Current ENERGY STAR Certified Homes Policy Record

ENERGY STAR Certified Homes Policy Record

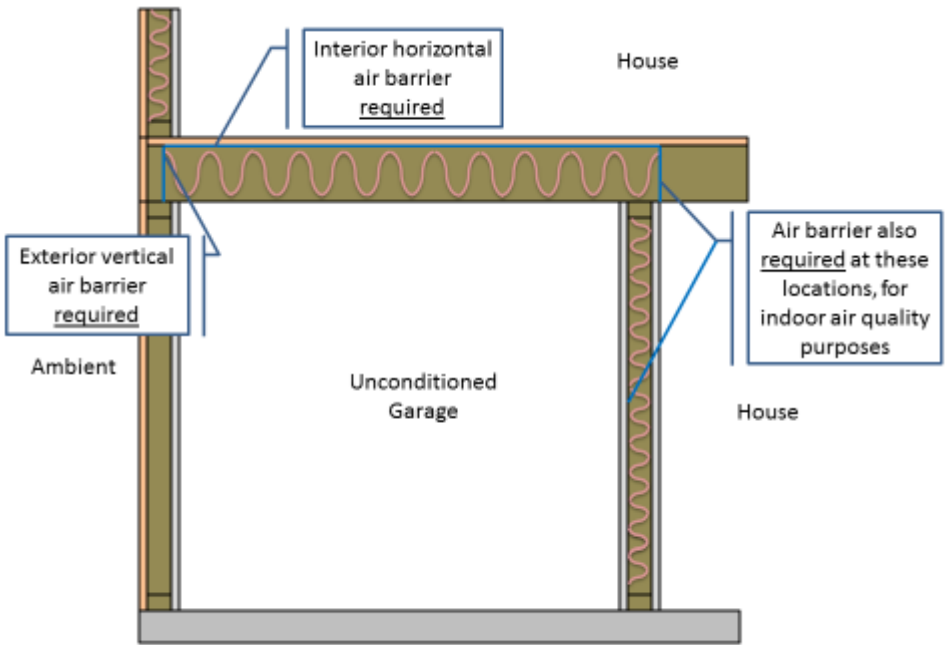
<p>Partners have also noted several inconsistencies in the terminology used throughout Section 3 and its Footnotes, such as “blocking at exposed edge”, which simply implies a vertical air barrier at the exterior surface of the insulation.</p> <p>Resolution: To clarify the intended orientation of the air barrier for each assembly type, Section 3 will be edited to distinguish between vertical and horizontal air barriers for ceilings, walls, and floors, as well as to define the required locations of the air barriers relative to the surface of the insulation. The requirements for each component type (i.e., ceiling, walls, and floors) will be grouped with the details associated with that component (e.g., ceiling requirements will be grouped with the list of ceiling details that must be inspected).</p> <p>The requirements for floors will be clarified by:</p> <ul style="list-style-type: none"> - Relocating all floor details into the Floors Section - Clarifying that an air barrier is always required at the exterior vertical surface of floor insulation - Clarifying that an air barrier is also required at the interior horizontal surface of the floor insulation, if located over unconditioned space. - Clarifying that an air barrier is recommended, but not required, at the interior vertical surface of all floor insulation in CZ 4-8. <p>In addition, the language regarding wind baffles at ceiling insulation will be made more consistent.</p> <p>Finally, the phrase, “blocking at exposed edge” in the section on floors will be rephrased as a requirement for an air barrier at the “exterior vertical surfaces of floor insulation”. The revised language in Section 3 will be as follows:</p> <p>“At each insulated location below, a complete air barrier shall be provided that is fully aligned as follows:</p> <ul style="list-style-type: none"> • <u>Ceilings</u>: At interior or exterior horizontal surface of ceiling insulation in Climate Zones 1-3; at interior horizontal surface of ceiling insulation in Climate Zones 4-8. Also, at exterior vertical surface of ceiling insulation in all climate zones (e.g., using a wind baffle that extends to the full height of the insulation in every bay or a tabbed baffle in each bay with a soffit vent that prevents wind washing in adjacent bays) • <u>Walls</u>: At exterior vertical surface of wall insulation in all climate zones; also at interior vertical surface of wall insulation in Climate Zones 4-8 • <u>Floors</u>: At exterior vertical surface of floor insulation in all climate zones and, if over unconditioned space, also at interior horizontal surface including supports to ensure alignment. See Footnotes 10 and 11 for alternatives” <p>The following details within each section will be modified:</p>

<p>Walls:</p> <ul style="list-style-type: none"> Item 3.1.5 will be revised to state, “Walls adjoining porch roofs or garages” Item 3.1.8, garage rim / band joist adjoining conditioned space, will be deleted and a new Item added to the Floors Section to address this detail. <p>Floors:</p> <ul style="list-style-type: none"> A new Item will be added to address rim / band joists and other floors that are adjoining unconditioned space: “All other floors adjoining unconditioned space (e.g., rim / band joists at exterior wall or at porch roof)” <p>Per Policy Record Entry 00428, Footnotes 7 & 10 will be merged and renumbered to improve clarity and reflect new exemptions to the requirement for interior air barriers in basements. This new Footnote will be further modified as follows:</p> <p>“All insulated vertical surfaces are considered walls (e.g., above and below grade exterior walls, knee walls) and must meet the air barrier requirements for walls. The following exceptions apply: air barriers recommended, but not required, in adiabatic walls in multifamily dwellings; and, in Climate Zones 4 through 8, an air barrier at the interior vertical surface of insulation is recommended but not required in basement walls or crawlspace walls. For the purpose of these exceptions, a basement or crawlspace is a space for which $\geq 40\%$ of the total gross wall area is below-grade.”</p> <p>In addition, Footnote 7, which recommends the inclusion of an interior air barrier at rim / band joists in Climate Zones 4 through 8, will be refined to reflect this new policy and moved to Footnote 9 of the Rater Field Checklist, as follows:</p> <p>“EPA highly recommends, but does not require, an air barrier at the interior vertical surface of floor insulation in Climate Zones 4-8.”</p> <p>Exhibits 1 through 4 illustrate the clarified policy for floors.</p> <p>In Exhibit 1, the floor is adjacent to the outdoors and over an unconditioned basement. An air barrier is therefore required at the exterior vertical surface of the floor insulation and at the interior horizontal surface of the insulation. In addition, if the home was in CZ 4-8, an air barrier would also be recommended, but not required, at the interior vertical surface of the insulation.</p>

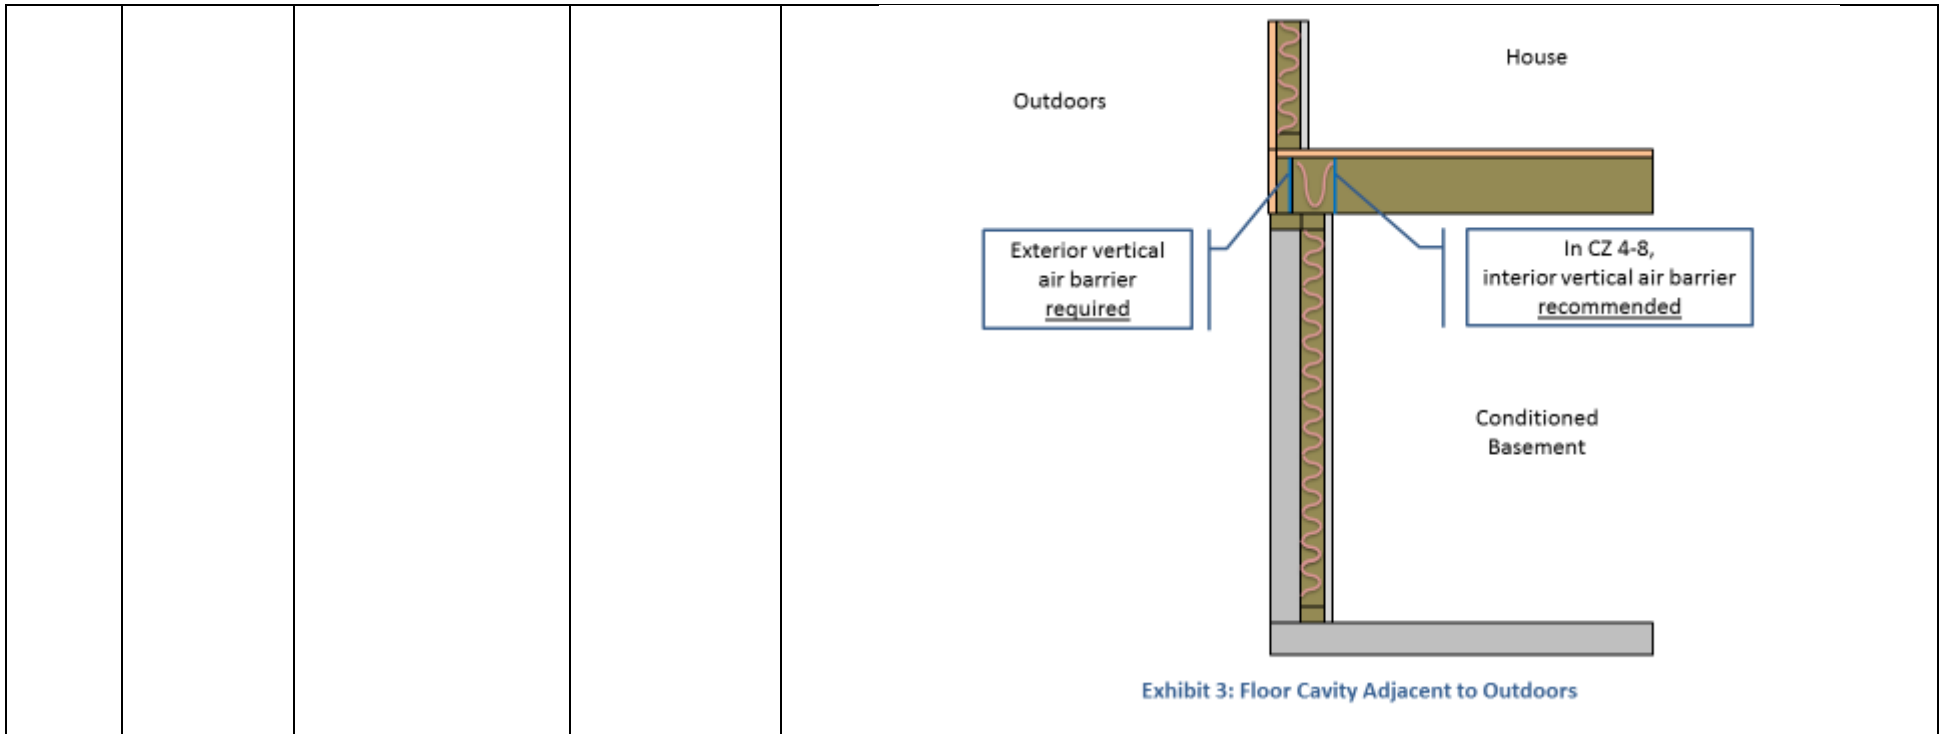
<p data-bbox="1228 868 1690 925">Exhibit 2: Floor Cavity Adjacent to Outdoors & Over Unconditioned Garage</p> <p data-bbox="892 933 2005 1088">Exhibits 3 & 4 show configurations where the floor cavity is adjoining unconditioned space, the outdoors and a porch roof, respectively. However, in both cases, these floors are not located over unconditioned space. Therefore, the only air barrier required is at the exterior vertical surface of the insulation. If these configurations were located in CZ 4-8, then an interior vertical air barrier would also be recommended, but not required.</p>
--	--	--	--	---

Exhibit 5: Floor Cavity Adjacent to & Over Outdoors

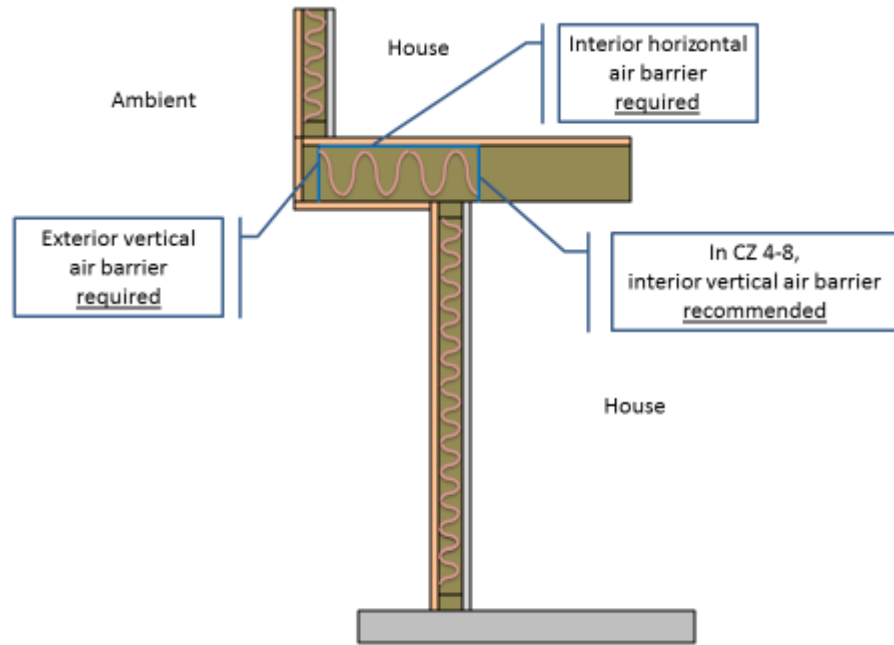
In Exhibit 5, a cantilever configuration is illustrated, in which the floor is both adjacent to and over the outdoors. Therefore, an air barrier is required at the exterior vertical surface of the insulation and at the interior horizontal surface of the insulation. If the configuration was located in CZ 4-8, then an interior vertical air barrier would also be recommended. Finally, as a best practice, an air barrier would also be included at the exterior horizontal surface of the insulation.
